**Bid #CA23-2526**  
**WEST VALLEY-MISSION COMMUNITY COLLEGE**  
**DISTRICT**  
**WV STEM CLASSROOM HVAC UPGRADES**

**BID ADDENDUM NO. 1**

**PROJECT:** WEST VALLEY COLLEGE  
WV STEM CLASSROOM HVAC UPGRADES  
14000 Fruitvale Avenue  
Saratoga, CA95070

**ADDENDUM DATE:** May 13<sup>th</sup>, 2026

POINT	DESCRIPTION	TYPE	UNITS
S	FAN STATUS (THRU CURRENT SWITCH)	DI	-
SF SC	SUPPLY FAN SPEED CONTROL	AO	0-10 V
EF SC	EXHAUST FAN SPEED CONTROL	AO	0-10 V

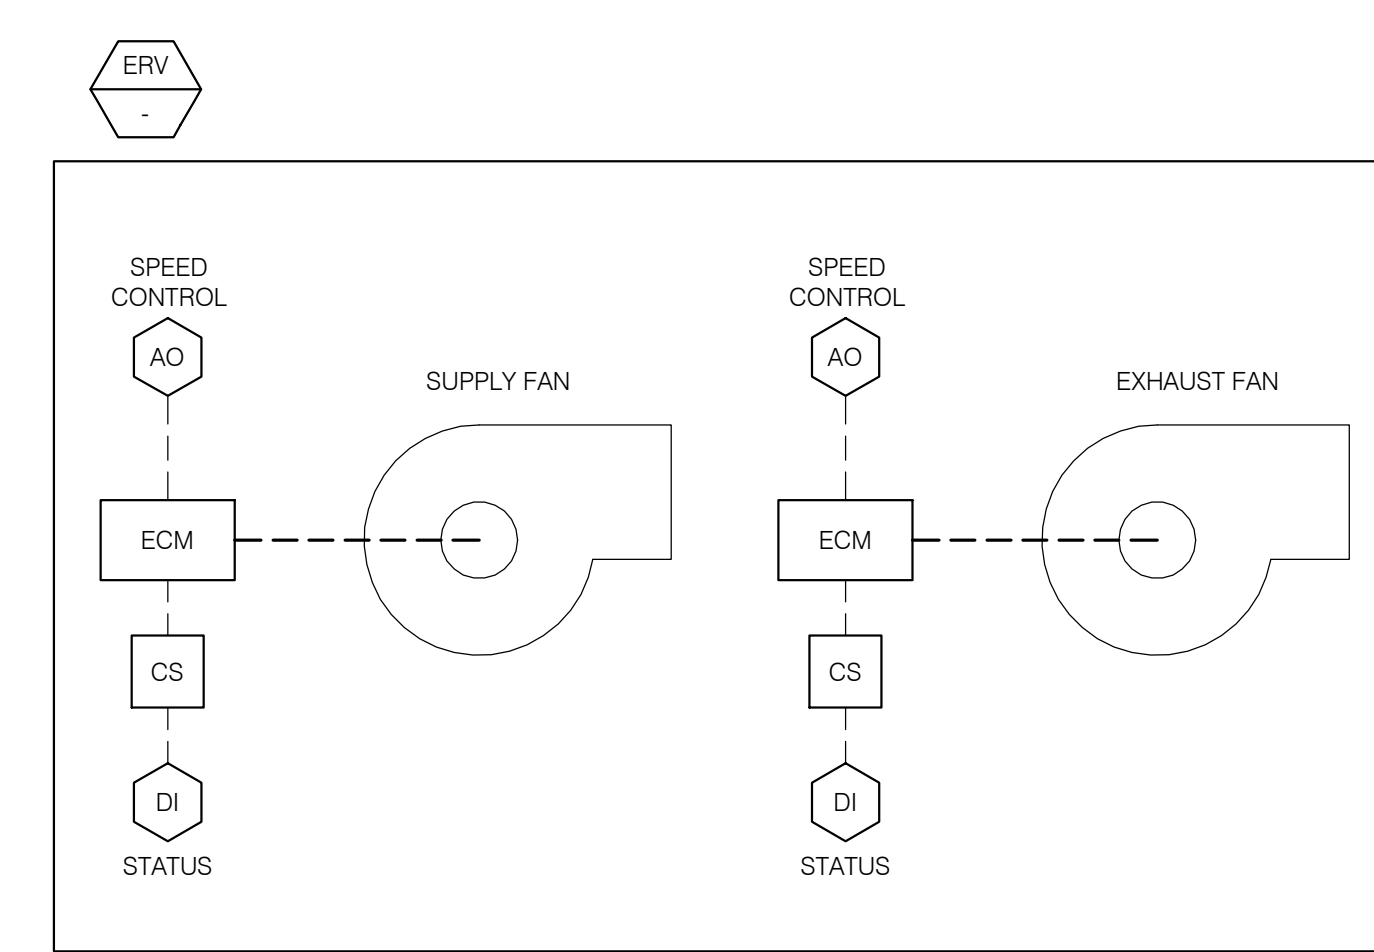
- NOTES**
- 1 PROVIDE PRESSURE GAUGE ON HOOD FOR ANALOG INDICATION OF PRESSURE WITHIN HOOD.
  - 2 AFA 800 FUME HOOD ALARM
  - 3 EXISTING INTERFACE FIRE ALARM SYSTEM TO REMAIN AND PROTECTED IN PLACE. CONTRACTOR TO VERIFY IN FIELD.
  - 4 PROVIDE INTERFACE TO ALARM SYSTEM FOR CODE REQUIRED SHUT DOWN.
